GOOD SAMARITAN HOSPITAL		06/05/2024
AMBULANCE BAY REVISIONS - PHASE I		
DRAWN BY: SBD	DATE: 06/05/2024

GOOD SAMARITAN HOSPITAL
AMBULANCE BAY REVISIONS - PHASE II
DRAWN BY: SBD

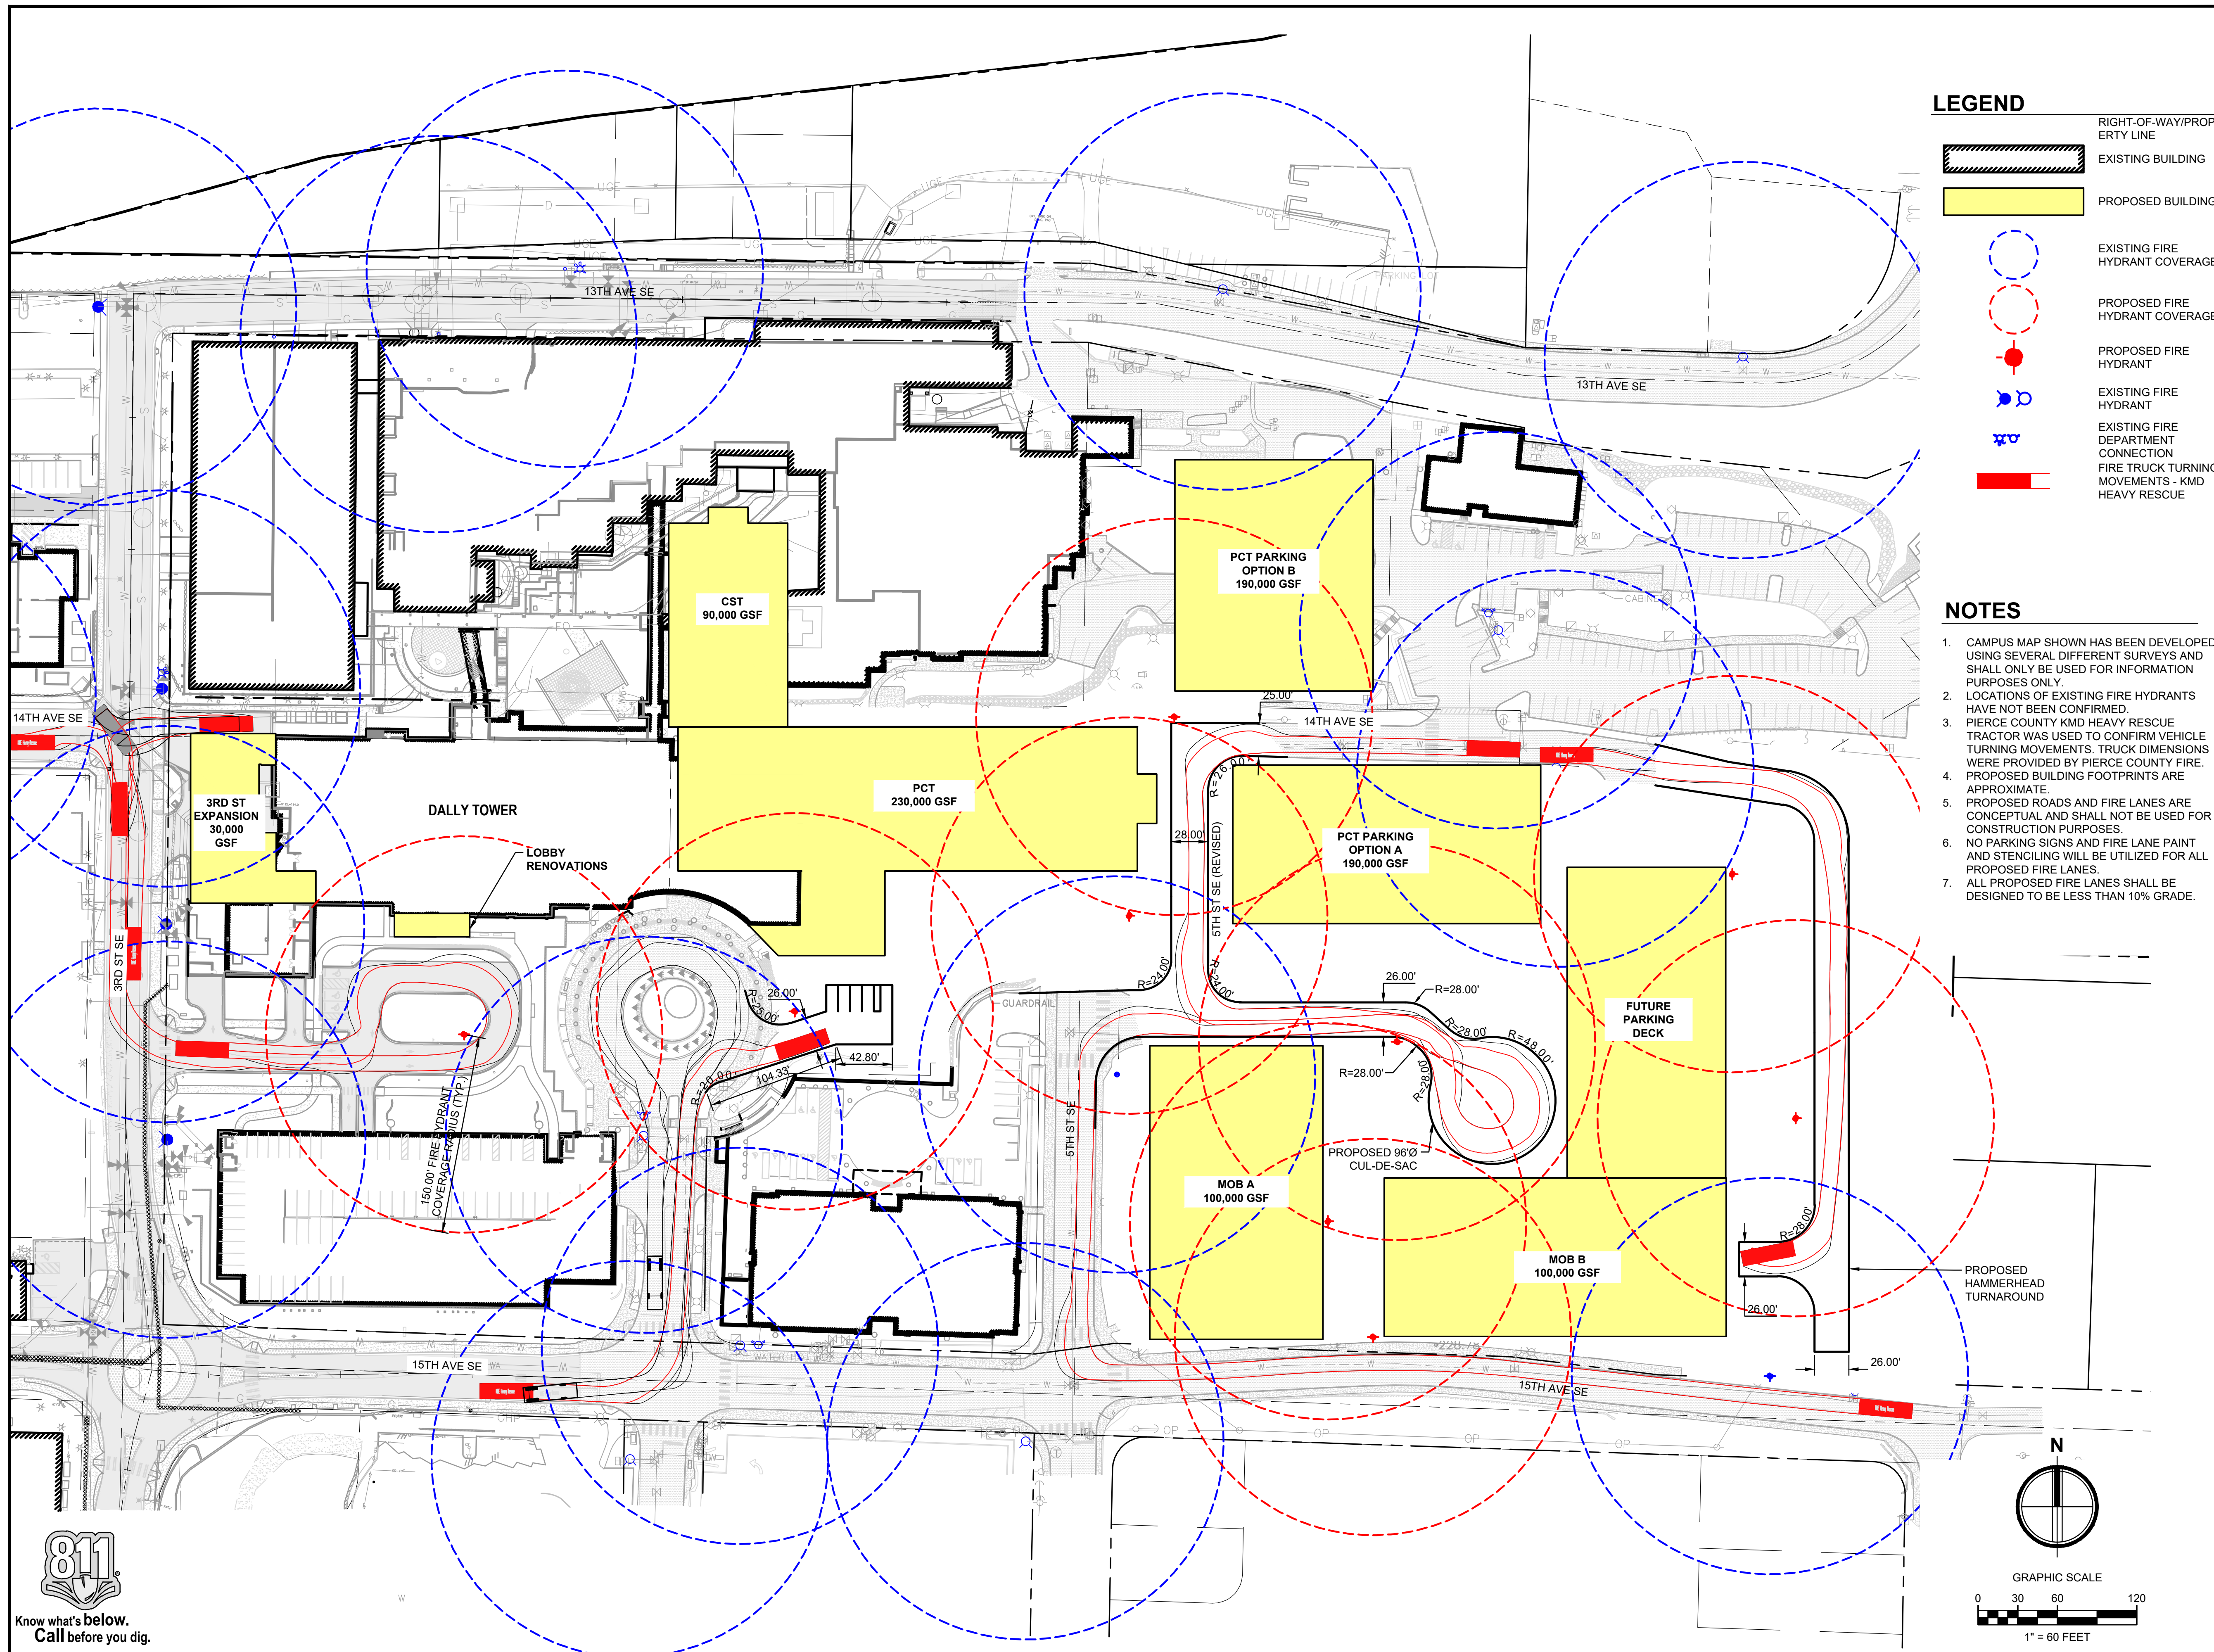
2	Consider in design, the ER Lobby cannot encroach into fire lane. Fire lane should be a minimum of 26' clear with for fire access.	Acknowledged and will address during building and site design and permitting.	Response remains the same.	Applicant needs to provide exhibit showing lane width is provided at the time of permitting for the ER lobby expansion. Condition of approval.
3	Auto-turn or equivalent program, will be required to demonstrate fire apparatus turning radius in all areas.	Comment acknowledged. MGSB will address minimum fire lane width during detailed building and site design and permitting.	Response remains the same.	Needs to be conducted prior to Master Plan approval. Applicant needs to provide auto turn analysis exhibit and submit for review.

Fire and EMS Master Plan Comments				
City of Puyallup				
4	Future support tower is encroaching in a specific fire access area. This will cut off required fire access and not be allowed without adequate accommodations.	Comment acknowledged. MGSB will address alternative fire access during detailed building and site design and permitting.	Response remains the same.	Needs to be conducted prior to Master Plan approval. Applicant needs to provide a revised site plan exhibit and additional written analysis from project architect demonstrating compliance.
5	5th street headed into 14th Ave SE needs a fire truck turn around.	Comment acknowledged. MGSB will address a turnaround or alternative fire access during detailed building and site design and permitting. Site grades may call for consideration of several alternative solutions.	MGSB will study and propose further detail on potential turn-around options for 5th to be included in the Master Plan.	Needs to be conducted prior to Master Plan approval. Applicant needs to provide a revised site plan exhibit and additional written analysis from project architect demonstrating compliance.

2		<p>See attached fire access plan showing a 26' minimum clear width for fire access will still be maintained with the expansion of the ED Lobby.</p>	<p>The Auto Turn is in adequate and shows multiple areas of running over curbs that could potentially hit a bystander. With this expansion, it clearly shows that curb, gutter, parking strips, and possibly sidewalk will need to be altered to accommodate proper fire access and turning radius.</p>	<p>The Emergency Department (ED) Lobby will not encroach into the fire lane, and drawings have been updated to reflect the appropriate physical scope of the work associated with that project in the Master Plan. The existing curb in the roundabout outside the ED Lobby conflicts with autoturns in the diagrams. This is an existing condition. MultiCare proposes to complete revisions to the roundabout curbs outside of the ED lobby as a condition of the completion of the ED lobby project to facilitate fire turning movements.</p>

3		<p>See attached fire access plan showing autoturn in all areas of the proposed Master Plan. The exhibit demonstrates that the fire apparatus will be able to access all of the proposed Master Plan facilities. Where needed, turnarounds are provided. We have also located existing and conceptual locations for fire hydrants on the site. These locations will need to be confirmed during final design and permitting of each structure.</p> <p>UPDATE 5/2: It was clarified that MGSB does not desire a connection between the main hospital roundabout entrance at 4th to 5th. Fire access is still maintained with removal of the connection. An updated diagram was provided to the City 4/29, and will be further updated with notes per the City's request on 5/2.</p>	<p>Based on the newest site plan, considering access to building, topography, and fire operational concerns the following need to be addressed.</p> <ul style="list-style-type: none"> o Show egress into the parking garages, are they a one way in and out or one entrance? o The fire truck "T" at the Eastside of 5th St Se needs to be a cul-de-sac for proper access. o The fire truck "T" at the end of 14th Ave SE needs to be extended as close as possible to 15th Ave SE. MOB B will require two points of access to be within 15-30' from the apparatus road. With 15th Ave. SE being elevated this will not be considered a point of access per the IFC. o The new fire lanes will be required to be a 26' unobstructed width. No parking signs will be required along with fire lane paint and stenciling. If there is a desire for parking on these access roads, the roads will be required be widen. What are the plans for the access roads per the IFC. 	<p>Please see the updated fire turning movements and hydrant availability analysis included with this response.</p>

4	CPFR Response: The MGS master plan architect/designer was tasked with ensuring the necessary changes were made to provide the FD with required accesses (maybe even a tunnel for extended hose lays) and turn-around points in accordance with the IFC and PMC.	There is a large slope between the proposed Support Tower and the existing building to the North, limiting vehicular access to this area. It was discussed with the City and Pierce Fire & Rescue that ladder truck access to this area is not needed, however, the design of this area will be required to provide accommodations and mitigation measures that will be refined further during final building design and building permitting.	This is a very critical item. Provide a comprehensive plan showing all exiting around the CST building that currently use this sloped area as evacuation. An understanding of this area needs to be determined now to avoid future code conflicts.	MultiCare's design team analyzed the existing life safety and exiting from the main Dally Tower and adjacent pavilions. Existing exiting is code compliant, and added capacities from the new PCT have been factored into the review of discharge locations. The proposed CST Location will impact the existing exiting plan, and the following mitigations are assumed to be needed to maintain code compliance for the new PCT and future CST projects: Fire Rated Exit Tunnel / Route, Relocated / Added FDC's, and exit route distance from the adjacent buildings, as noted in the attached diagrams. (Code : NFPA 101 Chapter 7, ICC Chapter 4, Chapter 10)
